Access Compliance Report

Public Rights-of-Way

(Curb Ramps)

Intersection ID: N/A	Main Street: KIRKWYND COMMONS DR	Cross Street: SHETLAND LN	Location: NW
ADA ID: E2280441BAE7	Ramp Type: PerpDiag	Initial Pass/Fail: Fail	Overall Compliance: No
Codes/Mitigation Info/Possible Solution		Field Measurements/Component Compliance

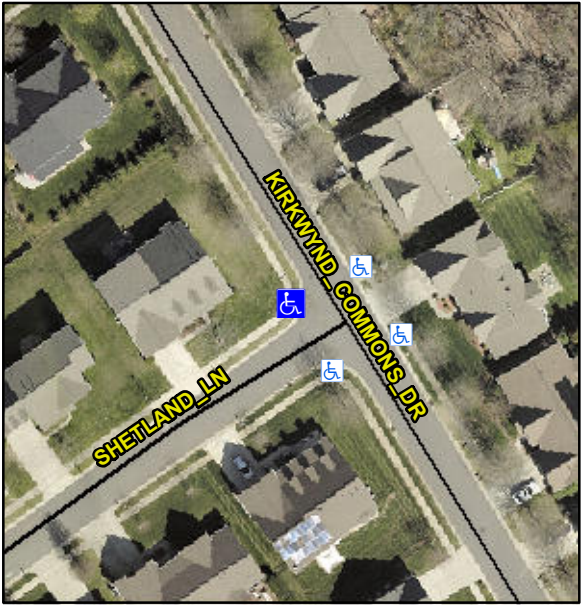
Possible Solutions:						
	Remove & Replace Curb Ramp With Two New Directional Ramps or Equivalent.	Compliance	Description	Data	Compliance	Description	Data
<p>Surveyor Notes:</p> <p>N/A</p> <p>PROW/ADA:</p> <p>Not Found, R304.2.2, R304.5.3</p>		N/A	Ramp Length (in)	45.0	No	Ramp Slope (%)	10.8
		Yes	Ramp Width (in)	48.0	No	Ramp XSlope (%)	4.2
<p>Total Cost:</p> <p>\$ 3200.00</p>		N/A	Flare Type LT	N/A	N/A	Flare Type RT	N/A
		N/A	Flare Slope LT (%)	N/A	N/A	Flare Slope RT (%)	N/A
		N/A	Flare Traversable LT?	N/A	N/A	Flare Traversable RT?	N/A
		N/A	Landing Length (in)	N/A	N/A	DWS Provided?	N/A
		N/A	Landing Width (in)	N/A	N/A	DWS Contrast?	N/A
		N/A	Landing Slope (%)	N/A	N/A	DWS Length (in)	N/A
		N/A	Landing X Slope (%)	N/A	N/A	DWS Full Width?	N/A
		N/A	Landing Curb? (Y/N)	N/A	N/A	DWS Offset (in)	N/A
		N/A	Shared Landing?	N/A			
		N/A	Gutter Ponding?	N/A	N/A	Gutter Slope (%)	N/A
		N/A	Gutter Lip Ht (in)	N/A	N/A	Gutter X Slope (%)	N/A
